Docket Item # 1 & 2
BAR CASE #2015-0164 & 0165

BAR Meeting
November 11, 2015

ISSUE: Permit to Demolish/Capsulate and Certificate of Appropriateness for an Addition and Alterations

LOCATION: 211 North West Street

Concept Review Submission

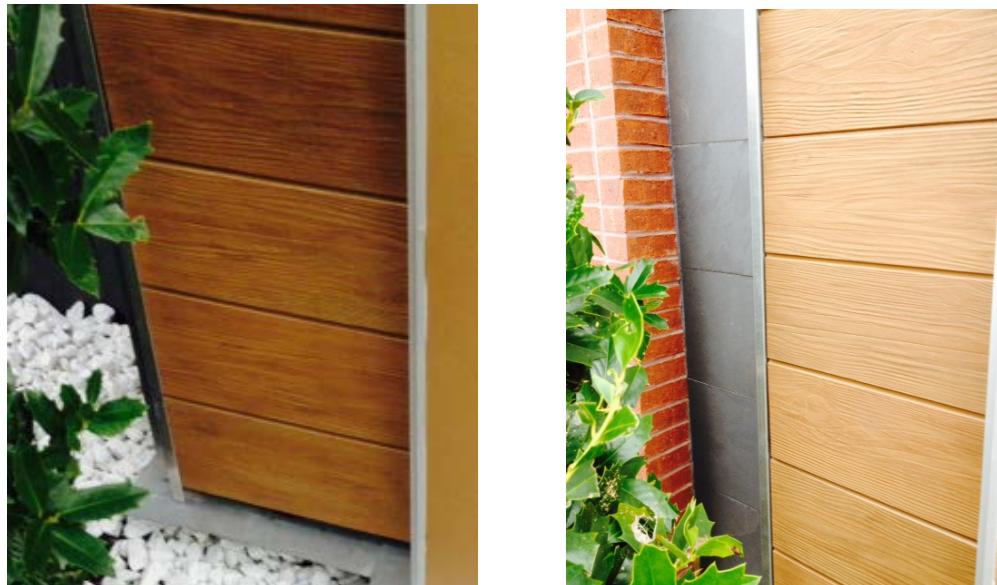
On July 22, 2015, the BAR evaluated Concept Review submission for a rooftop addition and alterations to the subject apartment building. At this hearing, the majority of the Board members expressed conceptual support for the project but objected to the scale and mass of the addition relative to the block face. The Board requested that prior to a Certificate of Appropriateness submission the applicant:

- Work to reduce the building's visual mass. The Board suggestions included lowering the addition's roof height or relocation of the addition's front setback to reduce its visual bulk;
- Provide the proposed modern design vocabulary for the building and include material specifications and details for the Board's consideration.

The attached submittal includes the applicant's revised design in response to the BAR comments at the July 22, 2015 Concept Review hearing. The changes to the original design include:

- An increase to the rooftop addition's setback from the front building wall from four feet (4') to fifteen feet (15');
- A reduction of the apparent height of the rooftop addition by two feet. This visual reduction was accomplished by changing the original shed roof form to a flat roof structure with a glazed, roof monitor. (The monitor is set back 22' from the front building wall.)
- Elimination of the small, fourth floor balcony on the front and rear elevation.
- Per citizen request at the Concept Review hearing, on the North elevation clerestory windows have been utilized to minimize views from the addition to the north.
- Refinement of the details and materials.

REVISED SKETCH

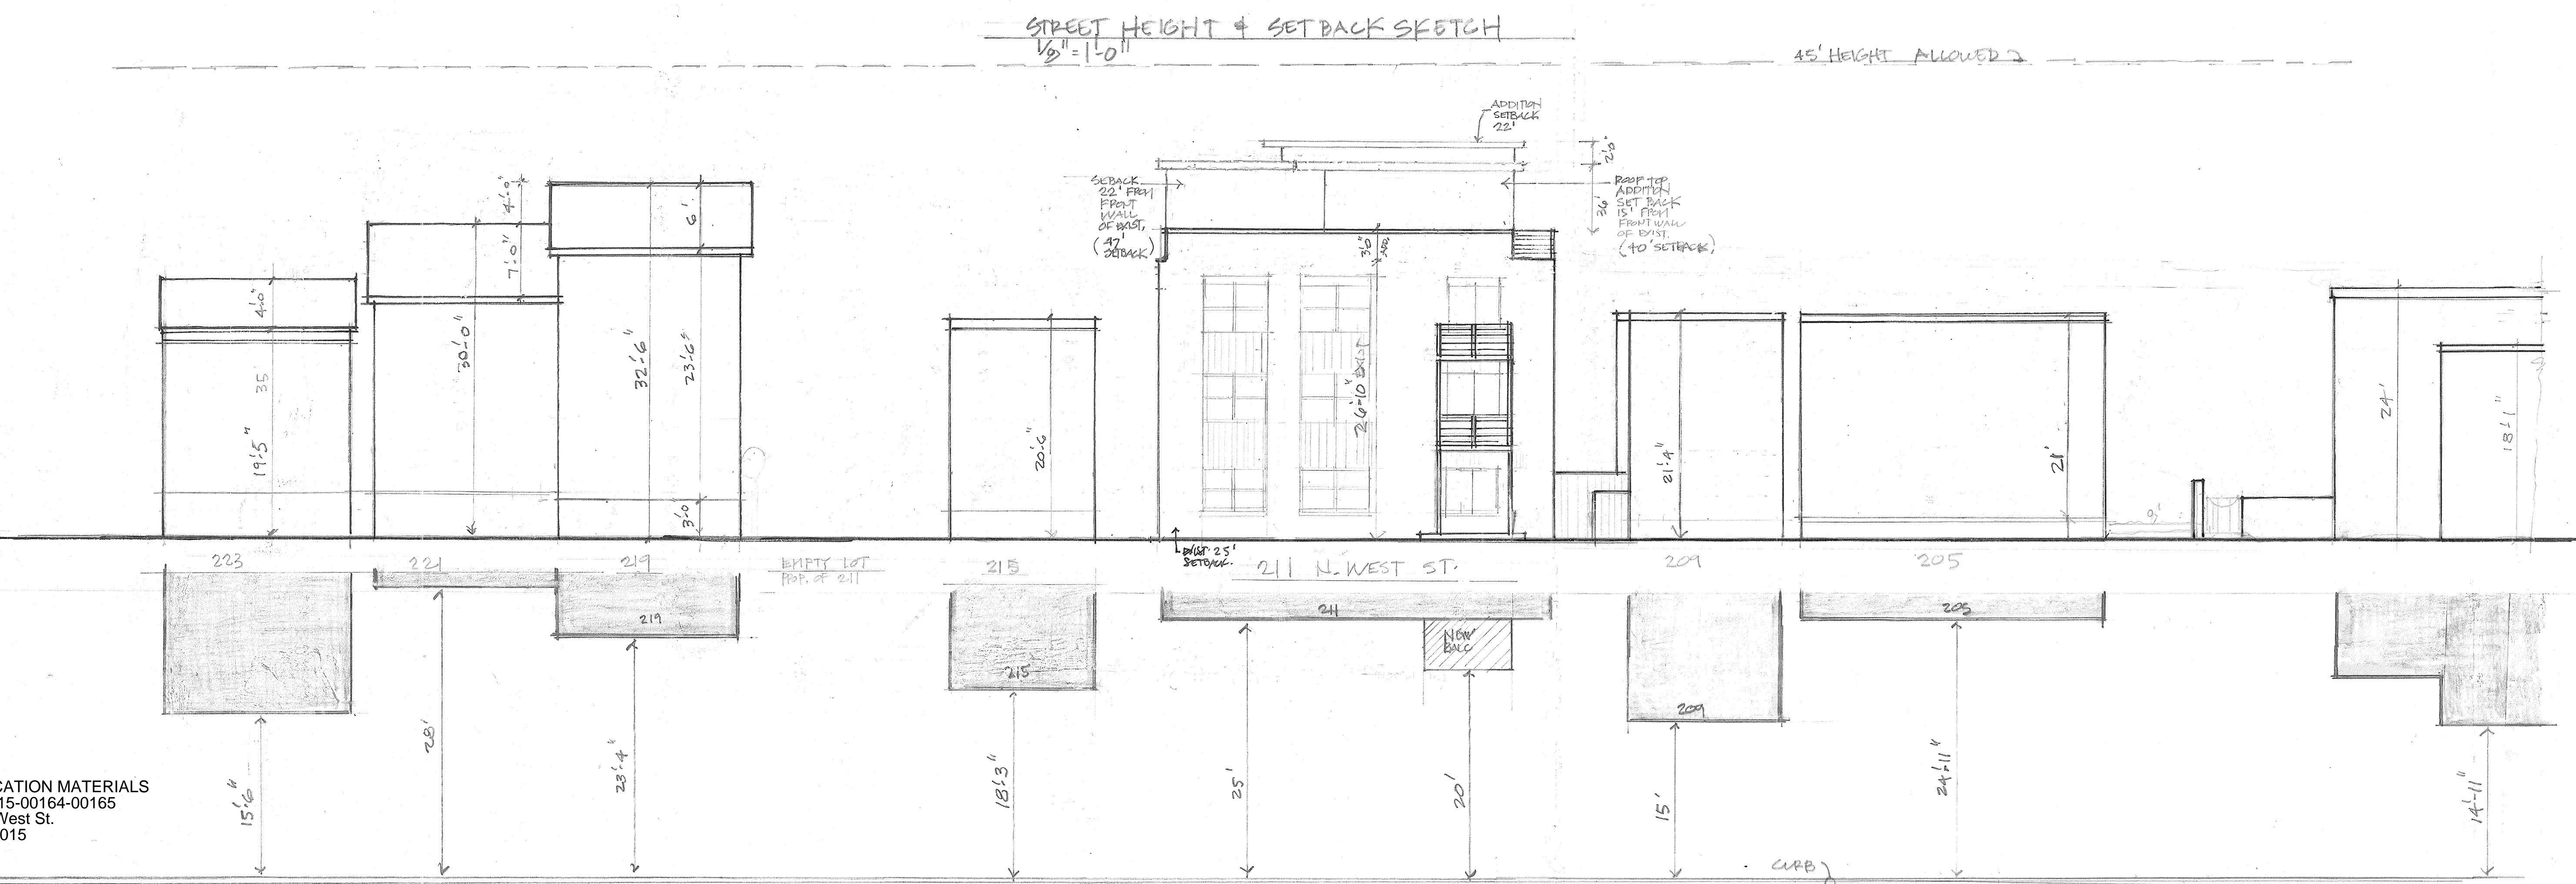
- There appear to be several encroachments into the required 5' north and south side yard setbacks that do not comply with zoning:
 - Front and rear decks/balconies
 - 4th floor overhang
 - Applied architectural feature on the north elevation

1. UPPER ROOF 1'-0" OVERHANG - @ NORTH & SOUTH EAV.
2. FRONT BALCONY MEET 5'-0" SIDE YARD SETBACK
3. SOUTH WALL ADDITION MEETS 5'-0" SETBACK
4. NORTH WALL ADDITION MEETS 5'-0" SETBACK
5. FRONT NUMBERS - MOUNTED TO WEST WALL PROJECTION -
